A. EIS Submissions

SUBMISSION: GLADSTONE LNG PROJECT (SANTOS AND PETRONAS)

GLADSTONE LNG PROJECT

Scale: 1:35,000	Date: 05-Aug-2009	Drawn By: RC
Drawing No.: GLNG EIS - QER-01 090811	Rev. No.: 00	Client: MGA94

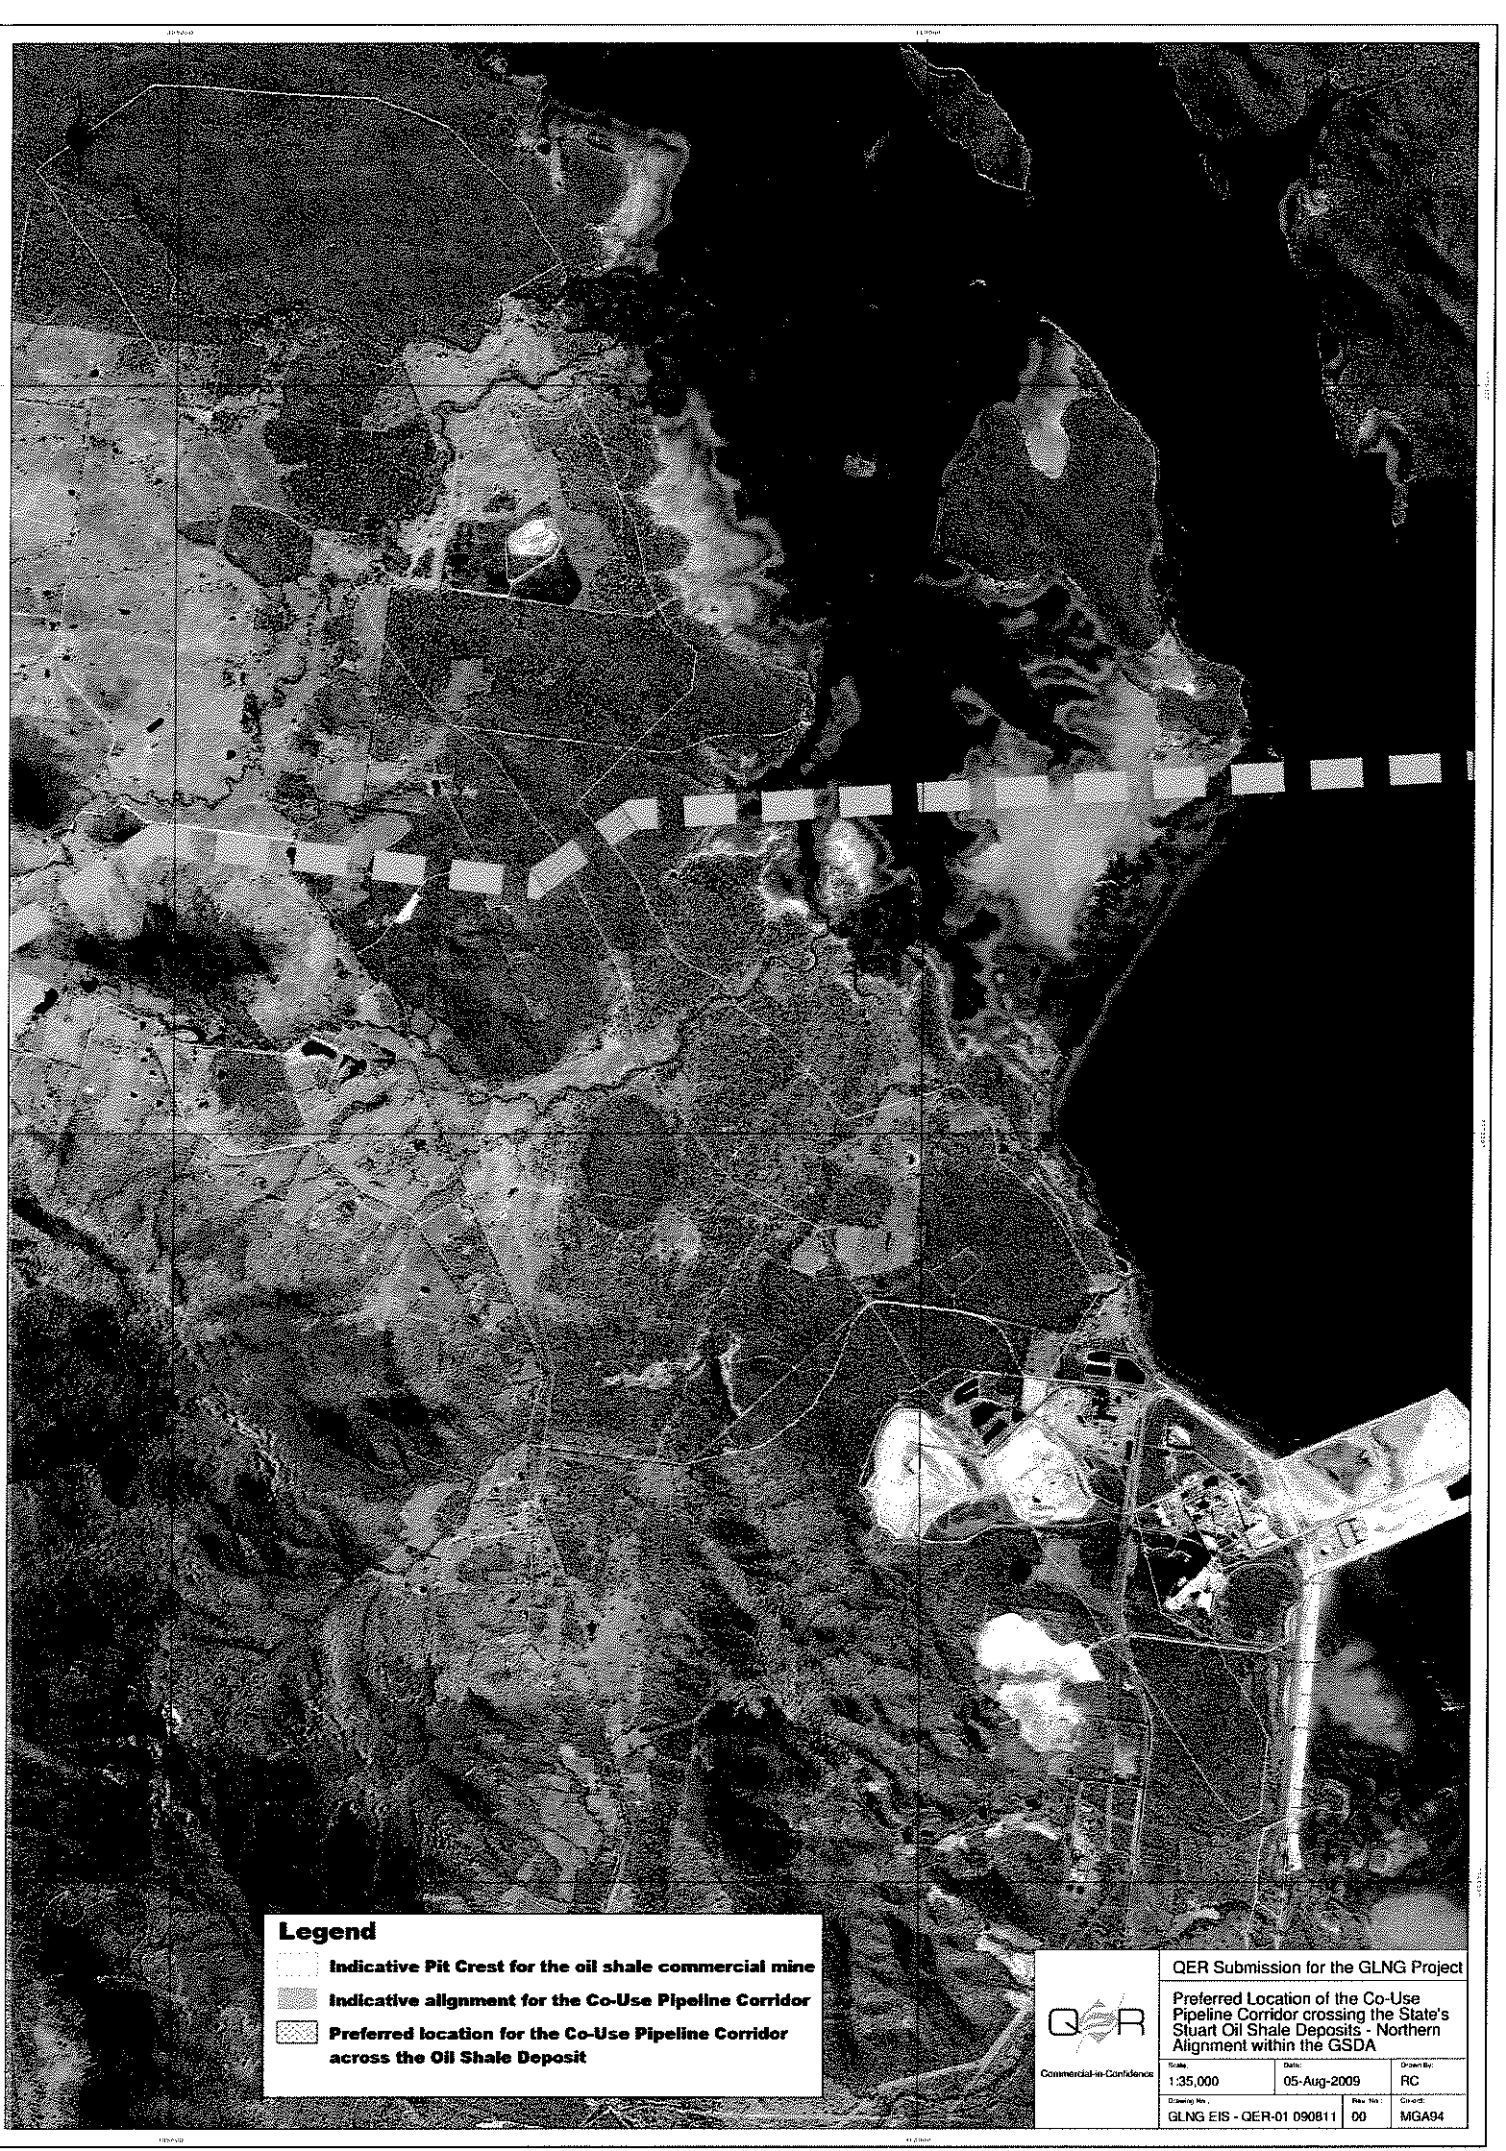
QER recommends and supports the DIP's approach of developing a common infrastructure corridor to service the LNG industry and recommends that, should a common Northern Infrastructure Corridor across the oil shale deposits proceed, the alignment should follow the above alignment (as described in the attached drawing titled "Preferred Location of the Co-Use Pipeline Corridor crossing the State's Stuart Oil Shale Deposits – Northern Alignment within the GSDA").

QER requests the Project's proponent liaise with QER, during its FEED process, to optimise any pipeline location. Please contact Richard Seton, Manager Infrastructure on 3222 0610.

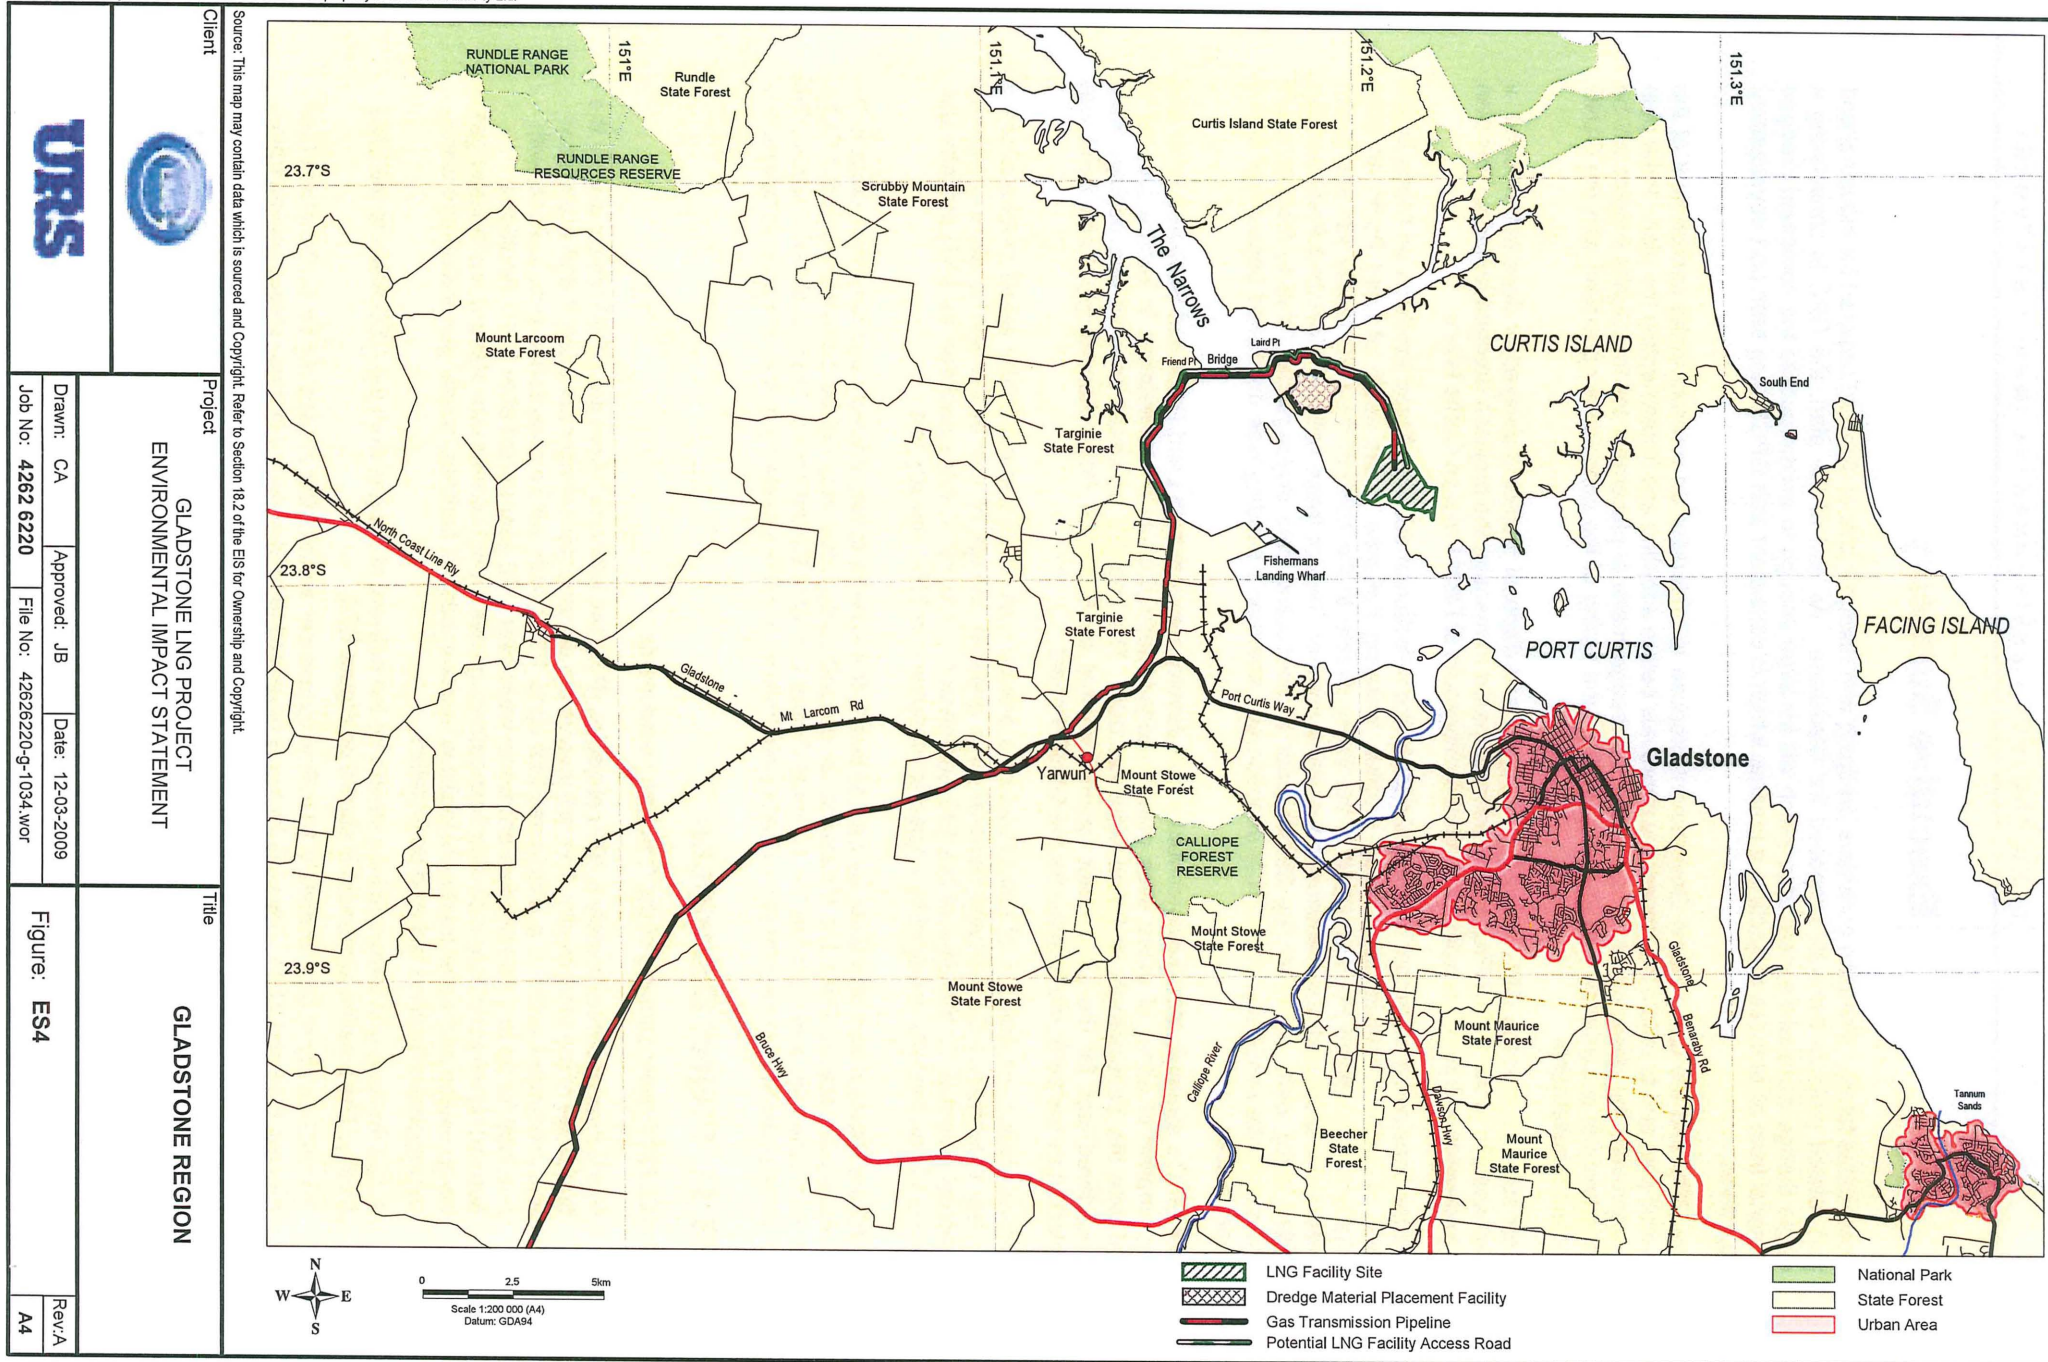
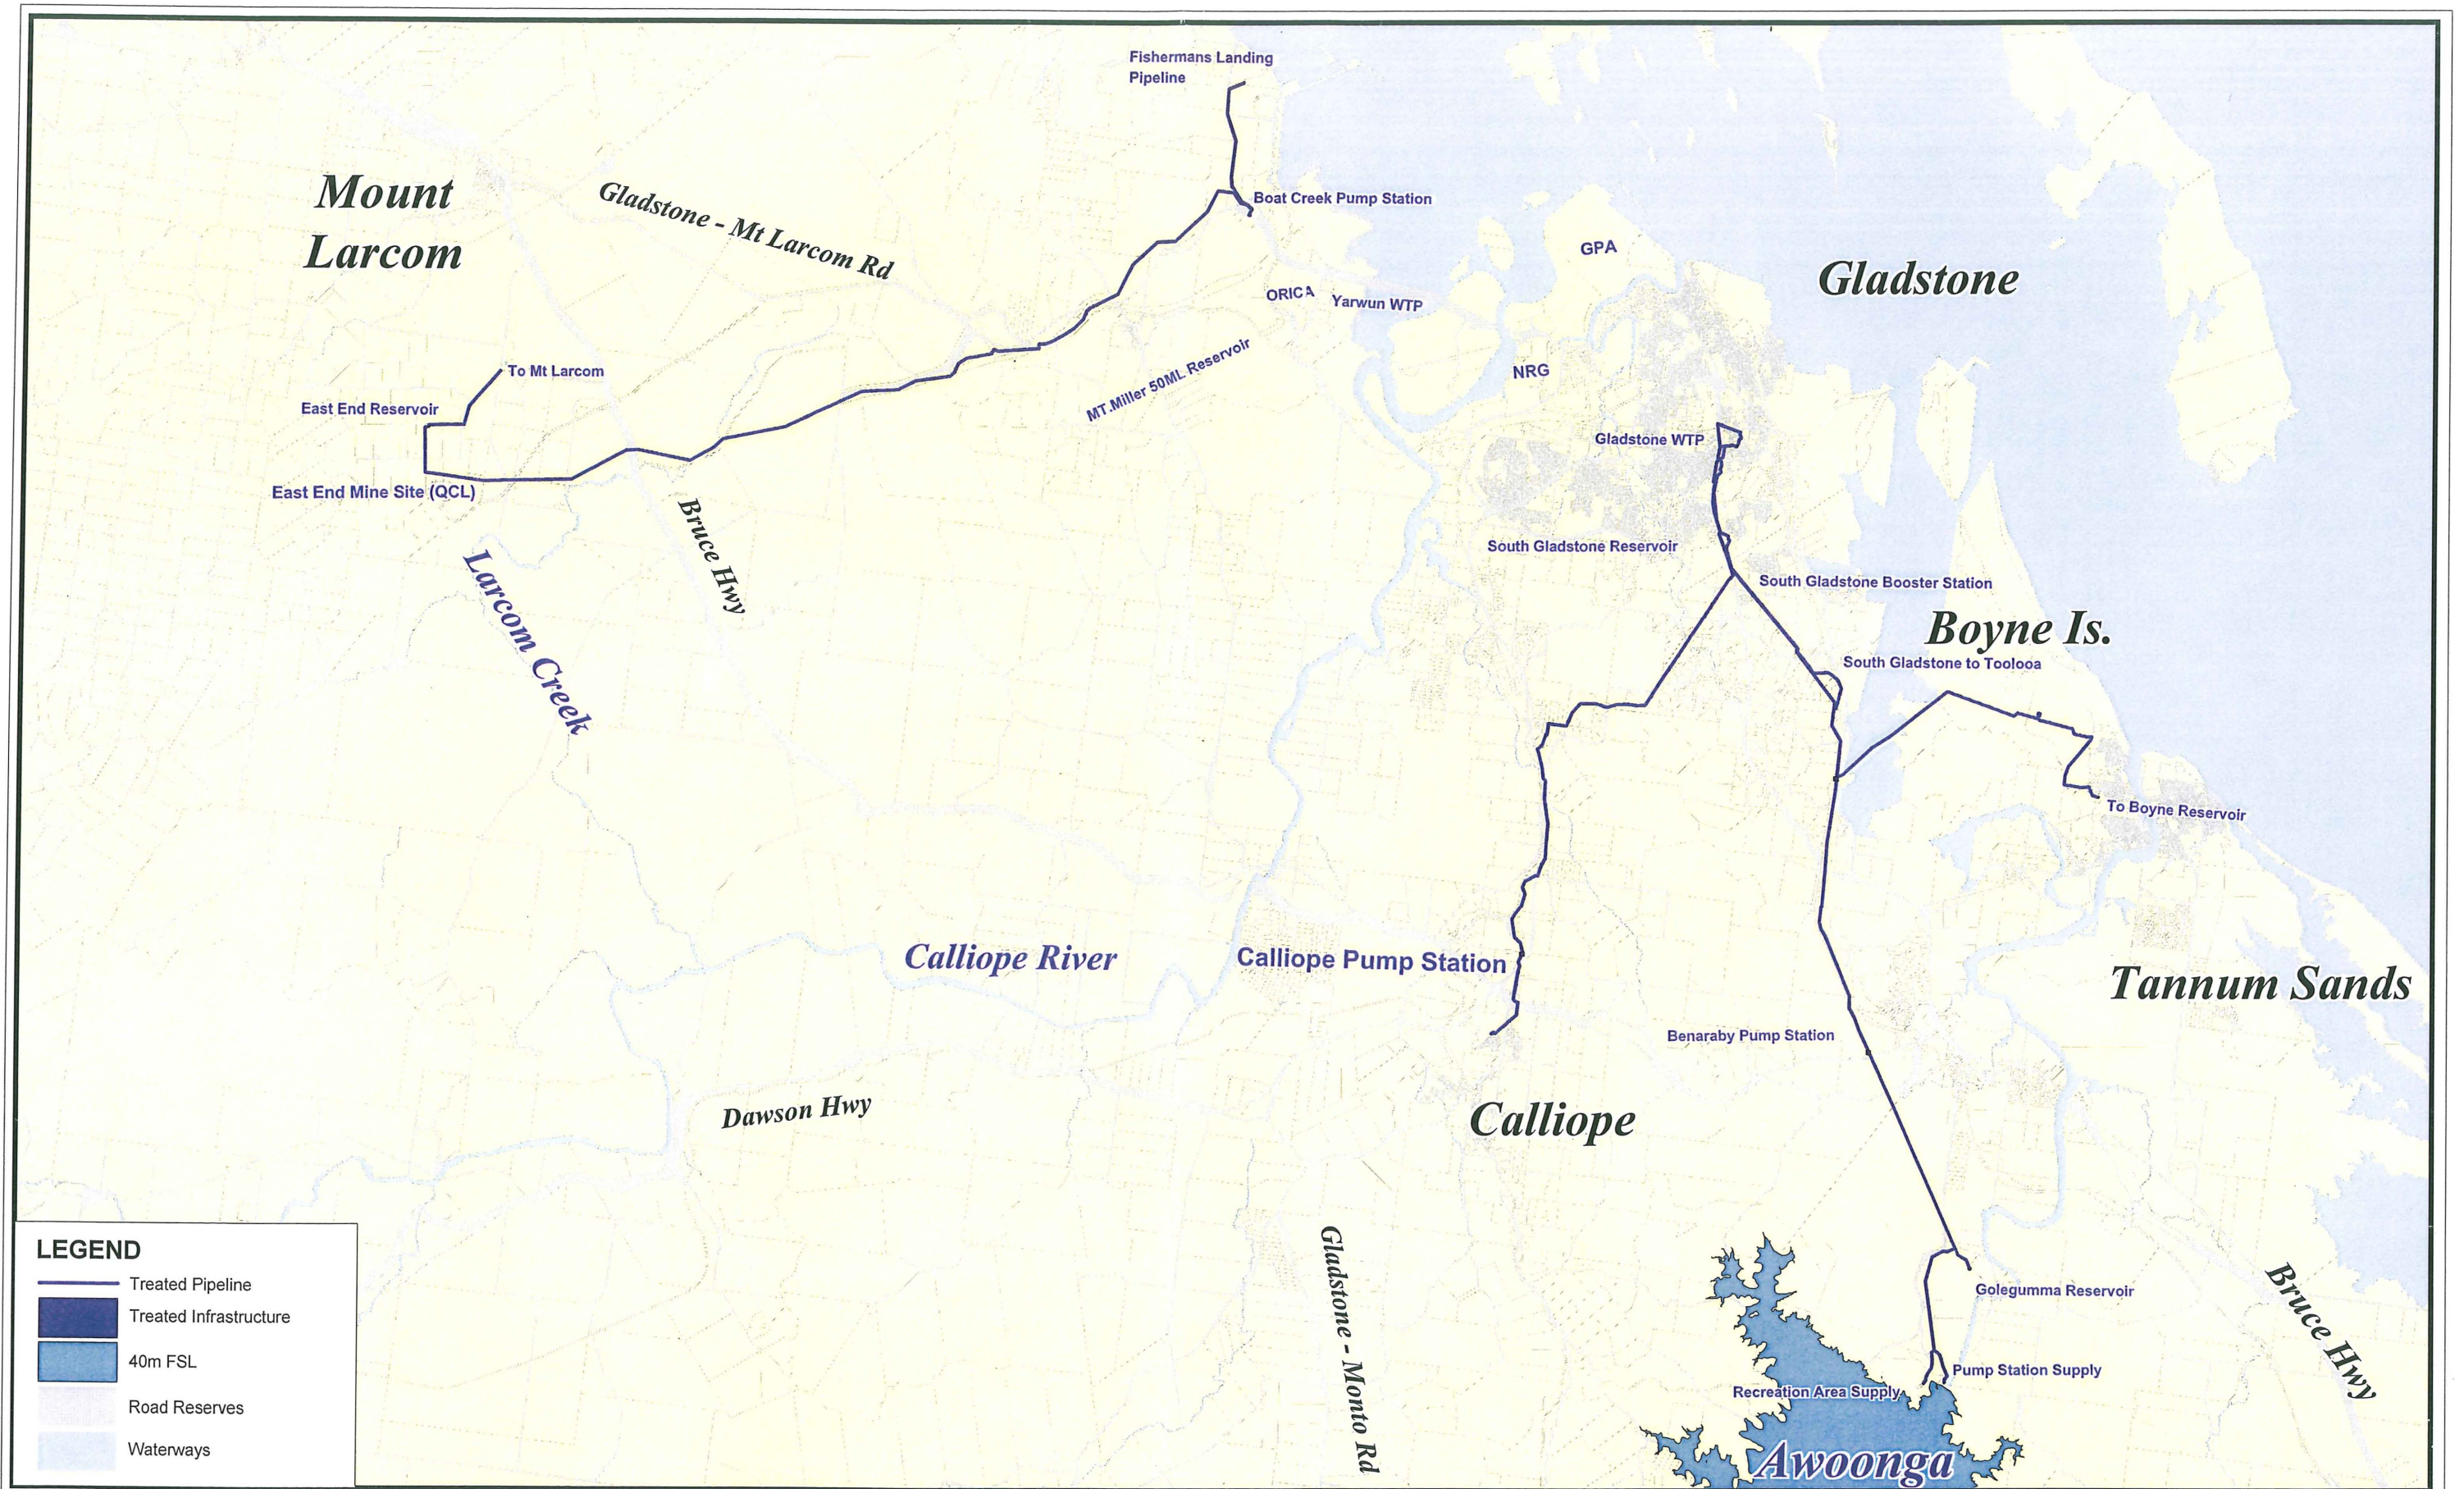
GAWB’s raw and potable water distribution network ends at Fisherman’s Landing area, only a short distance from the proposed GLNP pipeline crossing (refer to URS figure ES4, attached). GAWB’s raw and potable water networks have capacity to supply Curtis Island customers from this point.

Accordingly, it is submitted that there is merit in the Proponent (in consultation with GAWB) producing an analysis of the comparative environmental and economic impact should it meet its water supply requirements (both construction and operation) from GAWB's water supply network, as opposed to from a stand-alone desalination facility.
